RE: Meadow Springs Run Subdivision
LOCATION: Chartwood Drive and Meadow Rd
POD NO. 2023-00259

The Department of Public Utilities (DPU) has reviewed the subdivision construction plans submitted to the Planning Department on October 2, 2023.

PLAN
NOT TO SCALE

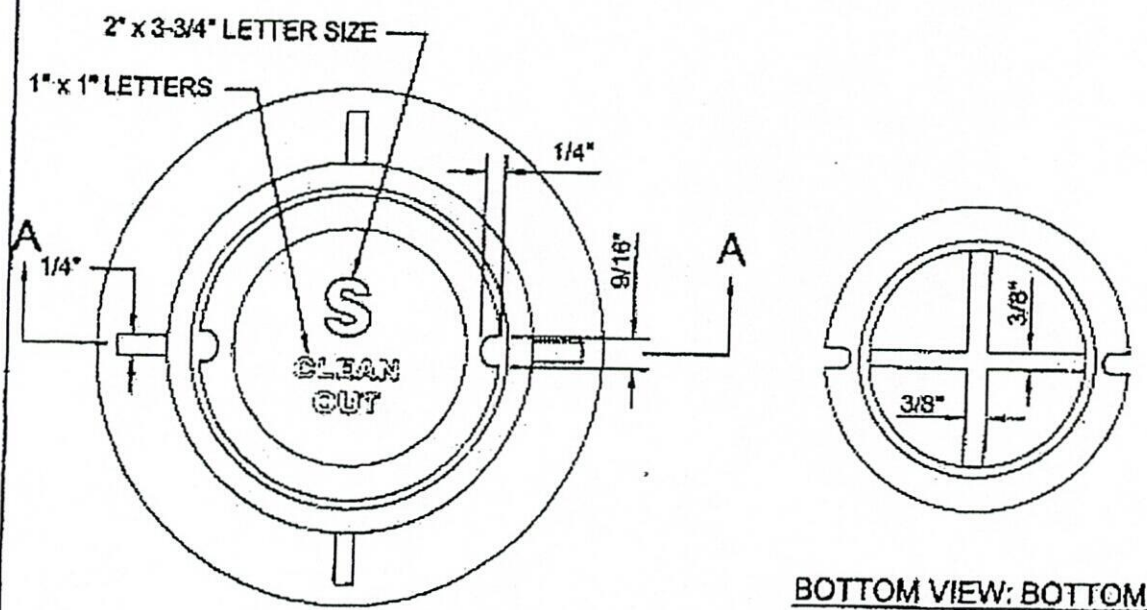
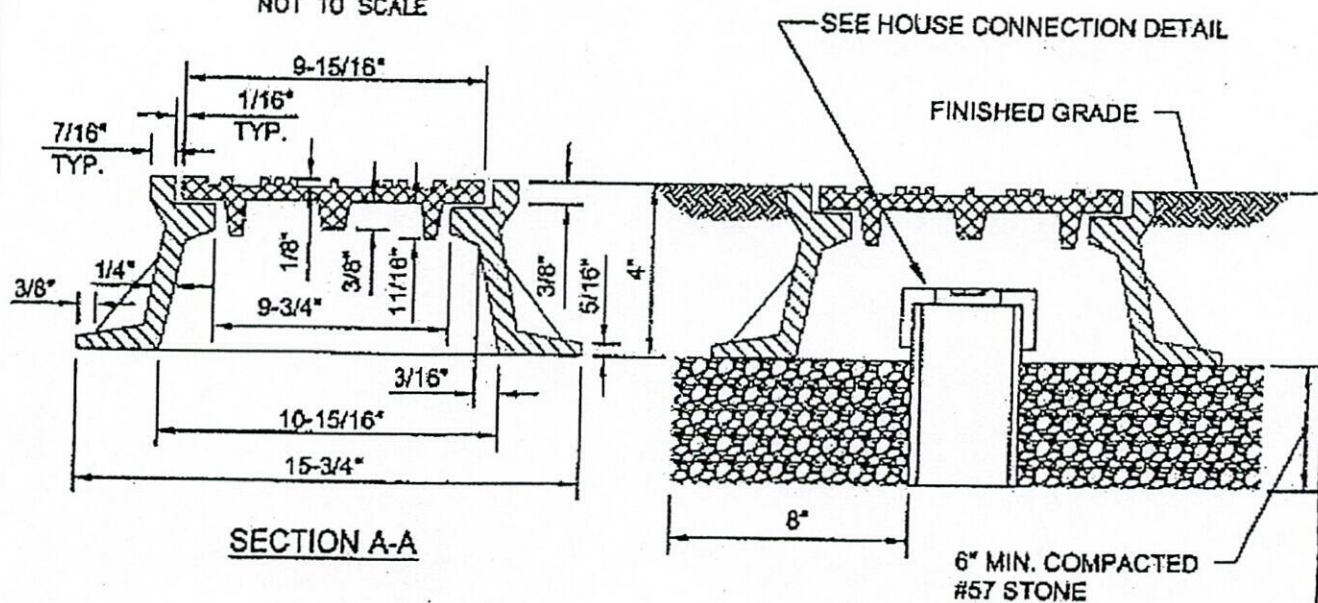
17. Provide a detail of a traffic rated SIP for if a lateral falls within the driveway. See enclosed example for traffic rated SIP. Also add a note that the lateral shall be replaced with DIP pipe material if within the driveway.
